INSTALLATION OF UNIVOLT V IN 1970 & 1971

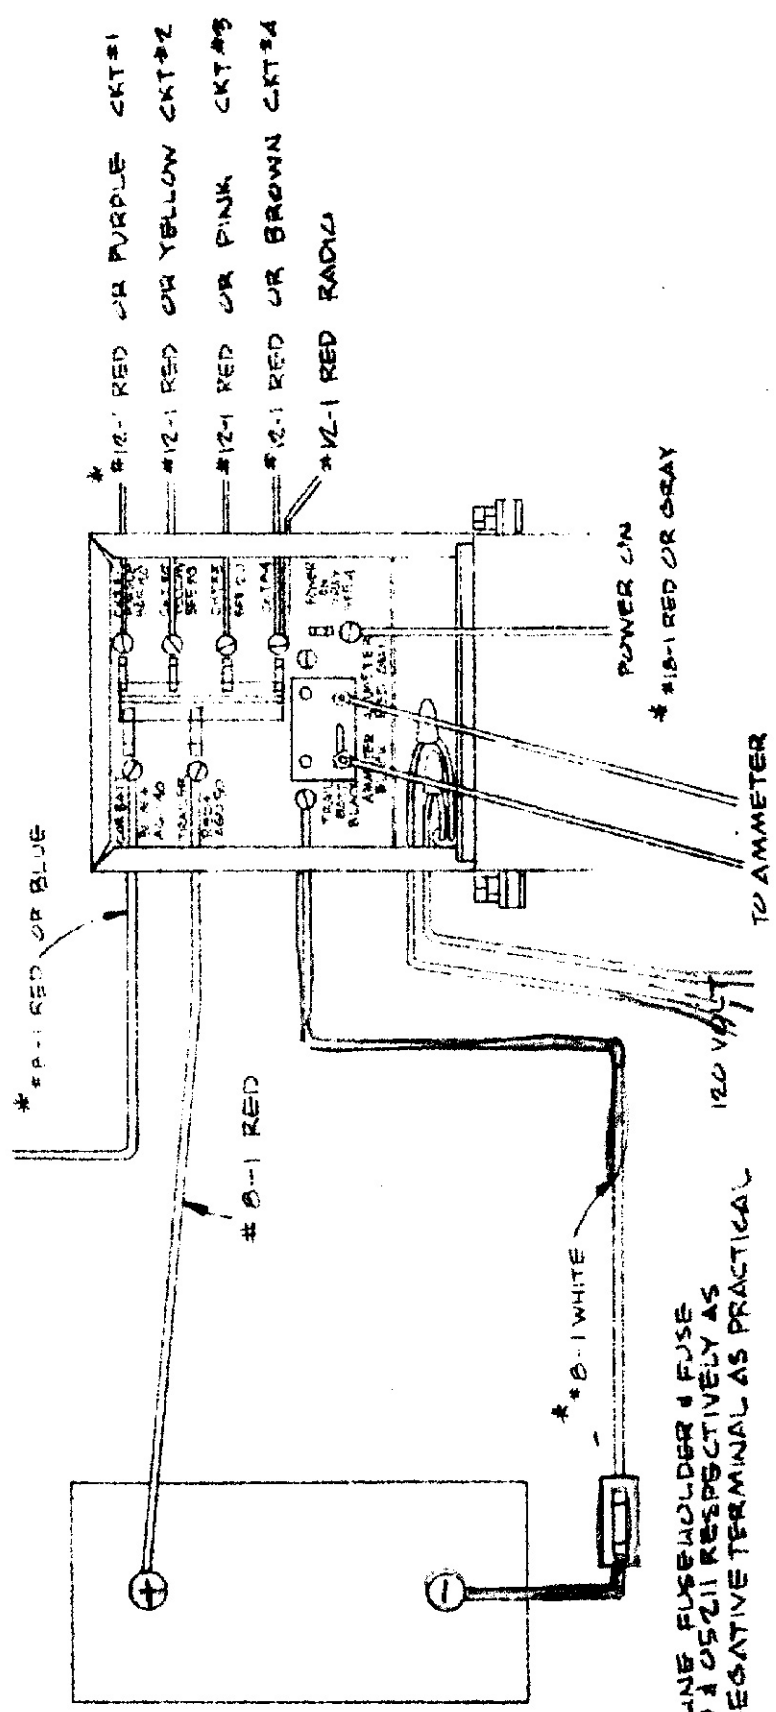
CHANGE TO
 (CENTRAL CONTROL PANEL BACKSIDE)

ADD 1972 INLINE FUSEHOLDER & FUSE
 P/N'S 05259 & 05211 RESPECTIVELY AS
 CLOSE TO NEGATIVE TERMINAL AS PRACTICAL
